## **BEL AIR EXECUTIVE PARK SUBDIVISION, SECOND UNIT, RESUBDIVISION OF LOTS 27, 28, AND 29**

### ***Revised for the May 3, 2007 meeting:***

# DETAIL SITE PLAN

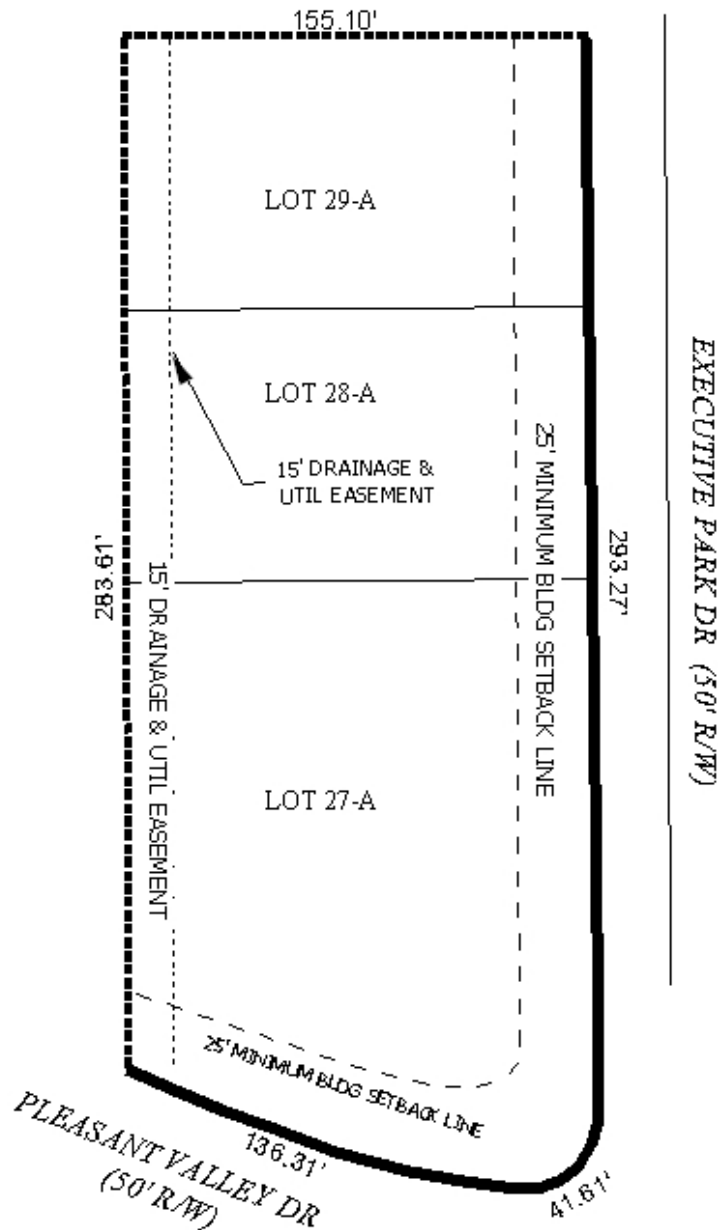
Since the creation of the lots, the right-of-way of Pleasant Valley Road was widened in order to change the route of the street to accommodate a new intersection with Cottage Hill Road. The plat provided with this application reflects the original 1978 layout, not the more current layout resulting from the acquisition of additional right-of-way for Pleasant Valley Road. The plat should be revised to reflect the changes.

*A revised plat provided by the applicant depicts the correct configuration of Pleasant Valley Road, however it appears that the right-of-way width label is incorrect: the actual right-of-way is wider than depicted on the plat. The right-of-way widths for Pleasant Valley Road and Executive Park drive are adequate.*

*Access management is a concern due to the width of the lots and the corner lot situation. Each lot should be limited to one curb-cut onto Executive Park Drive. Access to Pleasant Valley Road*

*for Lot 27-A should be denied. The size, design and location of all curb-cuts should be approved by Traffic Engineering and conform to AASHTO standards.*

*The plat should be revised to label each lot with its size in square feet, or a table should be provided on the plat with the same information.*

- 1) revision of the plat to depict the correct right-of-way width for Pleasant Valley Road;*
- 2) placement of a note on the plat stating that each lot is limited to one curb-cut onto Executive Park Drive, with the size, design and location of all curb-cuts to be approved by Traffic Engineering and conform to AASHTO standards;*
- 3) placement of a note on the plat stating that Lot 27-A is denied access to Pleasant Valley Road;*
- 4) revision of the plat to label each lot with its size in square feet, or provision of a table on the plat with the same information; and*
- 5) full compliance with all municipal codes and ordinances.*
